Department of Planning & Infrastructure

Cobbora Coal Project

Review of Surface Water Issues

October 2013

Figure 2.1:
Comparison of Contributing Catchment Areas for Original and Revised Mine Plans
(Source: Tables 2 to 6 of Appendix E of the Revised PPR)

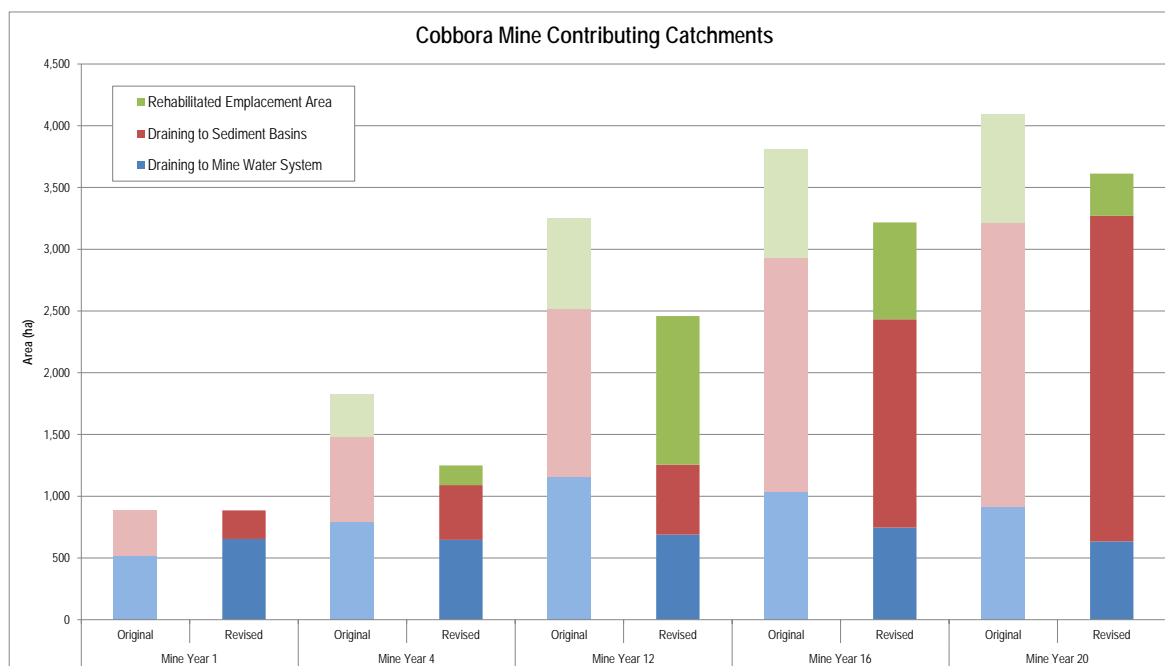
As shown in **Figure 2.1**, the revised mine plan (solid colours) provides a reduced area of the mine at all stages, with the final mine impacted area, including haul roads, reduced from 4,130 ha to 3,765 ha.

The revised mine plan also provides for a reduction in the area of the remnant void from 143 ha to 118 ha. However, the catchment area contributing to the remnant void is understood to remain the same (301 ha) as for the analysis provided in the *Water Balance and Water Management System – Addendum* (March 2013).

The revised mine plan provides an adequate general response to the PAC recommendations in relation to the reduced mine impact area. However, the revised mine plan lacks some details (eg comparison of haul road areas) to adequately justify the claimed water savings.

Figure 2.2:
Comparison of Annual Water Requirements for Tailings Conveyance
(Source: Figure 3.1, Appendix B)

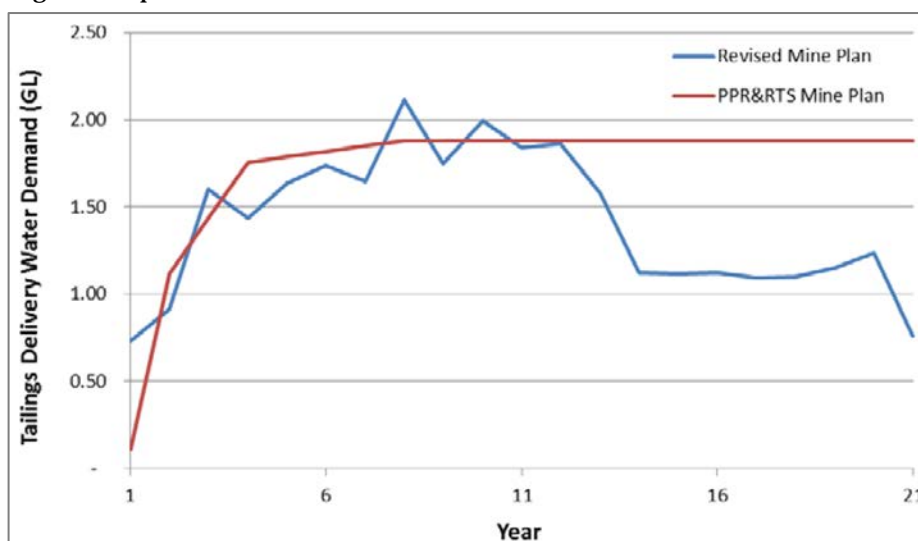
- While the combination of reduced tailing fraction and greater thickening efficiency implies a reduction in water requirements of the order of 35-45%, the overall life of mine reduction is only 18%. A further consideration is that the revised mine plan actually leads to a more than 10% increase in water demand for coal processing in Year 8 compared to the original plan. However, any potential risk of water shortfall in Year 8 could be mitigated by ensuring that there was sufficient carry-over in storage at the beginning of the year;

The data in the second last column of **Table 2.11** shows that the increased water demand for tailings disposal in Year 8 might actually lead to a slight increase in the maximum demand for water compared to the original mine plan. This is contrary to the conclusion set out below Table 9 in Appendix E:

Figure 2.3:
Estimated Mine Pit Inflows

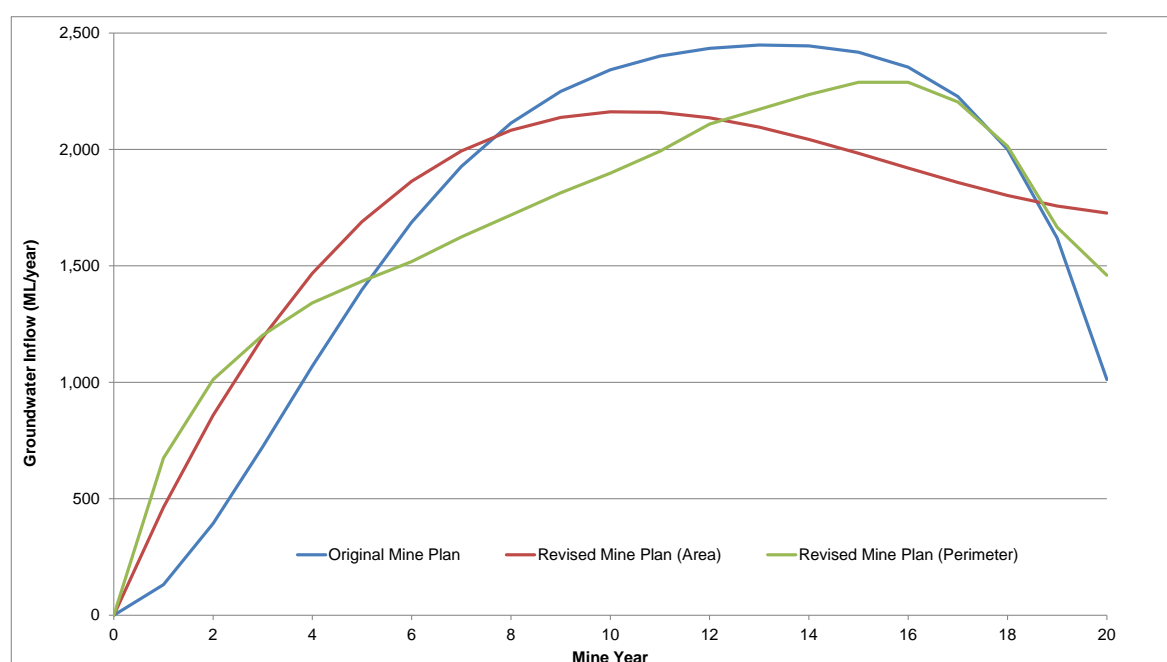
As shown in **Figure 2.3**, whichever basis is adopted for estimating groundwater inflows, the revised plan is likely to lead to increased groundwater flows in the early years and lower inflows during the later years. The peak inflows are likely to be of the order of 6-12% less than the predicted peak for the original mine plan.

The analysis set out above is based on the original groundwater modelling which assumed that all groundwater would report to the mine pits. The *Revised PPR* includes a proposal to utilise de-watering bores in order to minimise the evaporative losses that would occur with groundwater seepage direct to the pit. No separate analysis has been undertaken of the location or effectiveness of the groundwater bores needed to achieve the same de-watering as would occur with free groundwater seepage into the pit.

Figure 2.5:
Refuge Pool Location and Potential Impacts

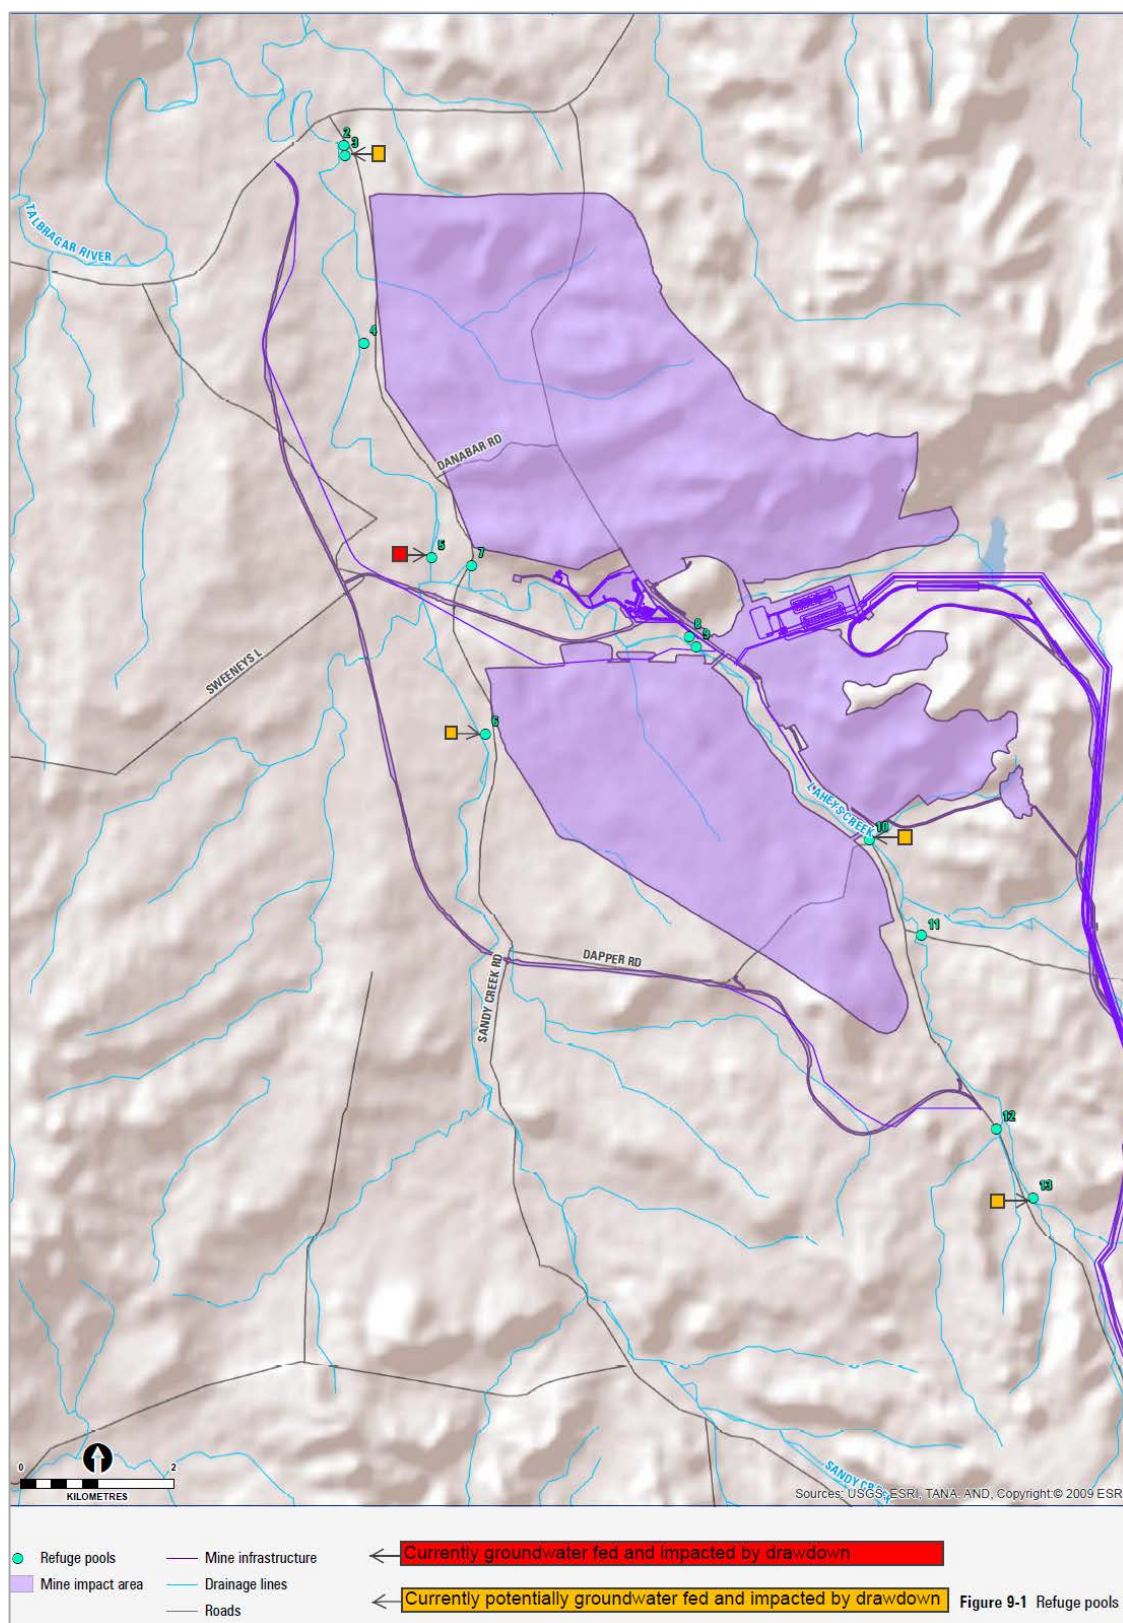
The *Revised PPR* states that CHC is committed to providing contingency measures for pools that could be affected by drawdown. An aquatic monitoring strategy will be developed to detect changes to the quality and quantity of water in semi-permanent pools. A River Monitoring Committee will be formed to review the results from this strategy and to assist formulate adaptive management measures. These measures may include releasing water from the mine site to fill pools. It may be necessary to transport the water by pipe or water truck if gravity feed is not possible for upstream locations or where water transmissions losses are unacceptable for downstream locations.

It is recommended that the proposed strategy for monitoring and managing the pools addresses water quality and temperature requirements for maintenance of the aquatic ecology in the pools. In view of the existing saline conditions in Sandy Creek, it may be necessary to shandy raw water from the Cudgong River with groundwater to mimic existing water quality conditions.

Figure 2.6:
Area reporting to sediment dams for original and revised mine plans

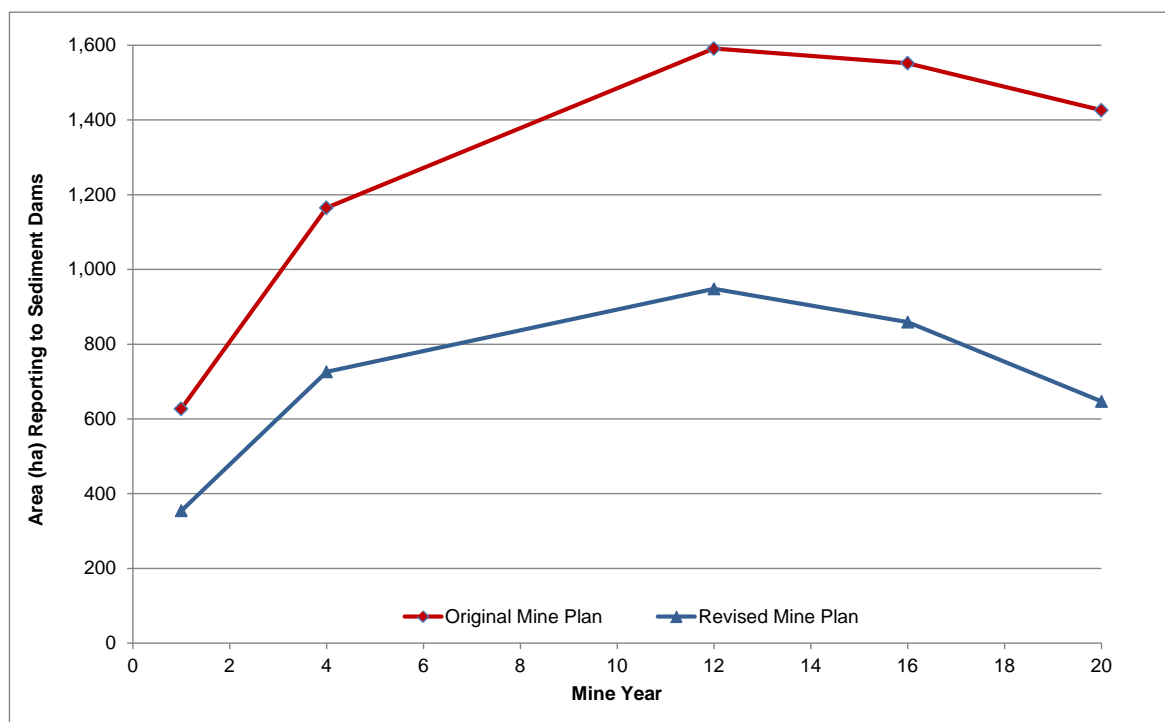
As stated in **Section 2.8.1** above, the *Revised PPR* assumes that if the area of the various land uses reduce or remain very similar to the original mine plan then it could be inferred that the impacts of the Project will be less than or similar to those already assessed. **Table 2.18** above summarises the change in area of the various land uses, including the areas that would drain to sediment dams (cleared areas, soil stockpiles, active overburden emplacement and rehabilitated emplacement areas [prior to full establishment of vegetation]). **Figure 2.6** summarises this information graphically and shows that the area draining to sediment dams for the revised mine plan would generally be in the range of 55% to 60% of the original mine plan. The total runoff from these areas can therefore be expected to be of the order of 55% to 60% of the estimates for the original mine plan and, provided the runoff from the overburden area is adequately managed, that the impacts would be no worse than for the original mine plan.

Figure 2.7:
Effect of Salinity on Evaporation

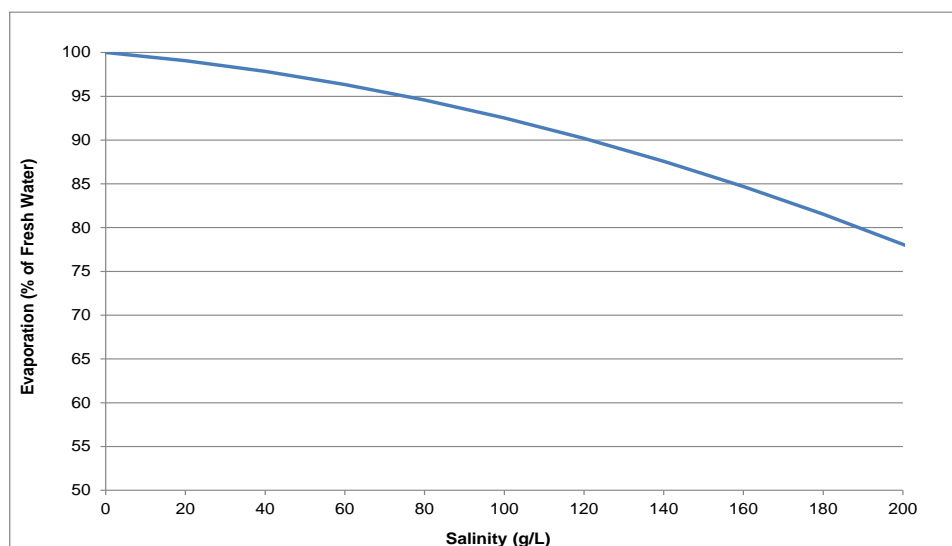
- There is no assessment of the potential long term effects of climate change;
- The analysis overlooks the fact that the evaporation rate will decline as the water increases in salinity. The general form of this relationship is shown in **Figure 2.7** which shows that at

the predicted salinity of 150,000 mg/L after 100 years, the evaporation rate would be about 86% of that for fresh water.

While these effects may offset each other, further analysis is warranted at the time of the preparation of the Site Water Management Plan to confirm the groundwater inflow relationship as well as take account of the sensitivity of the equilibrium lake level to climate change and salinity effects.
